ATTACHMENT A
Existing Specifications
Unit 2

ATTACHMENT C
Proposed Specifications
Unit 2

ENCLOSURE 2

PCNs 401, 405, 431, AND 429 MARKUPS

Figure 3.3-1
DEGRADED BUS VOLTAGE TRIP SETTING.

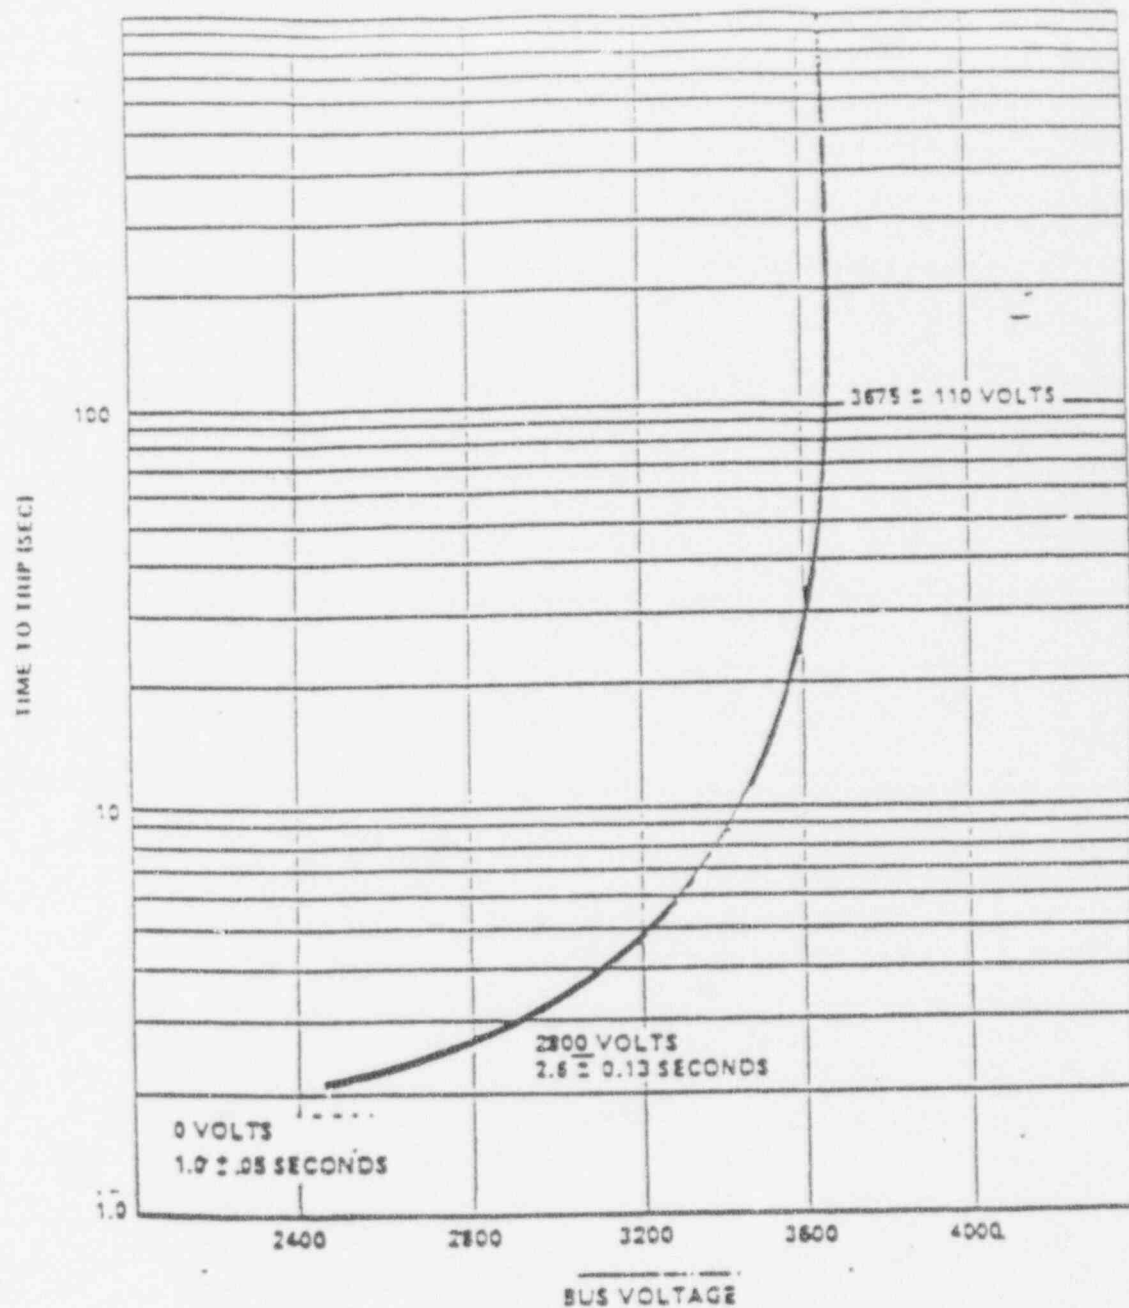
- (3) % of the distance between steam generator upper and lower level instrument nozzles.
- (4) ~~Inverse time relay set value 3165, trip will occur within the tolerances specified in Figure 3.3-1 for the range of bus voltages, deleted~~

~~Figure 3.3-1~~
~~DEGRADED BUS VOLTAGE TRIP SETTING~~
3/4 3-40

DELETED INTENTIONALLY

Figure 3.3-1
DEGRADED BUS VOLTAGE TRIP SETTING

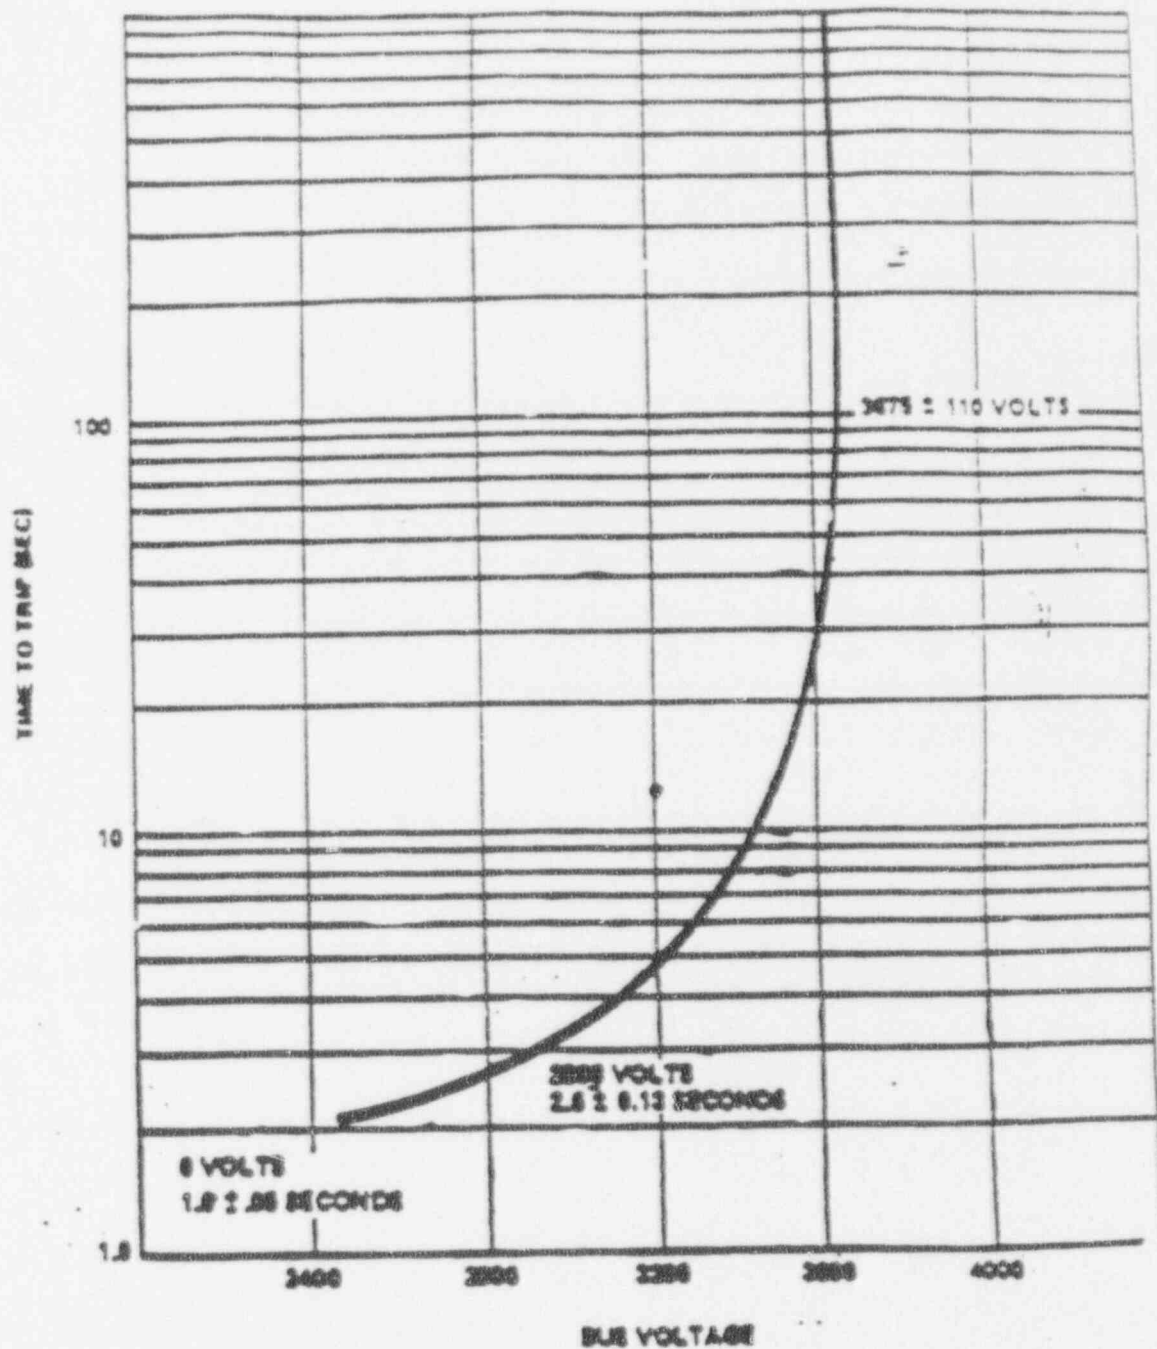
- (3) % of the distance between steam generator upper and lower level instrument nozzles.
- (4) ~~Inverse time relay set value 3165, trip will occur within the tolerances specified in Figure 3.3-1 for the range of bus voltages.~~deleted

~~Figure 3.3-1~~
~~DEGRADED BUS VOLTAGE TRIP SETTING~~

DELETED INTENTIONALLY
